Product Change Notification

1. ECR #: 221627
Notification #: 680

- IPD1 - MINI-POWER CONNECTOR
- MMSD - .100 SOCKET DISCREET CABLE ASSEMBLY

Color Shade Difference

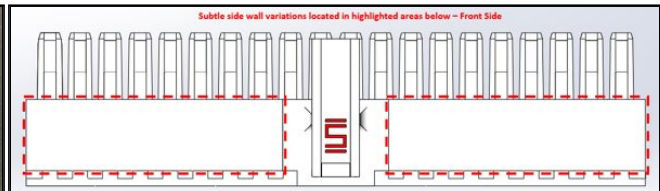
There will be an insulator color shade change. Also, subtle variations in the side wall geometry are possible in the future and notifications will not be sent with each minor change. This is a running change, and all variations of mixing old and new revisions will be possible for several months. The change is backward compatible.

This will be a non-functional color shade change for the insulator only. While old and new material often have lot-to-lot variation in shading, this new plastic will be noticeably lighter in shade. See images below for identifying the side wall modifications.

Subtle side wall variation location - Front Side

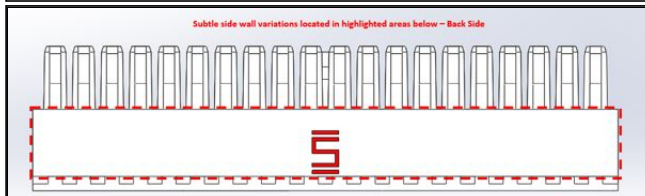
Raw material supplier is taking the existing material to end-of-life. Both the existing and new nylon 66 material are UL94 V0 rated. Side wall drafting improves the moldability of the insulator.
